REGULATION No. 43
(Safety glazing)

Proposal for Supplement 11 to Regulation No .43

Submitted by the expert from Spain

"Laminated glass panels other than windscreens

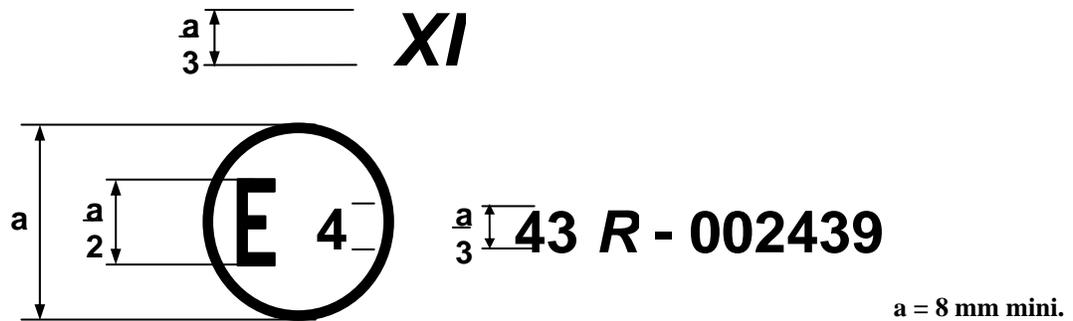
Add the following approval mark examples, to read:

The above approval mark affixed to a laminated glass pane other than a windscreen, shows that the component concerned has been approved in the Netherlands (E 4) pursuant to Regulation No. 43 under approval No. 002439. The approval number indicates that the approval was granted in accordance with the requirements of Regulation No. 43."
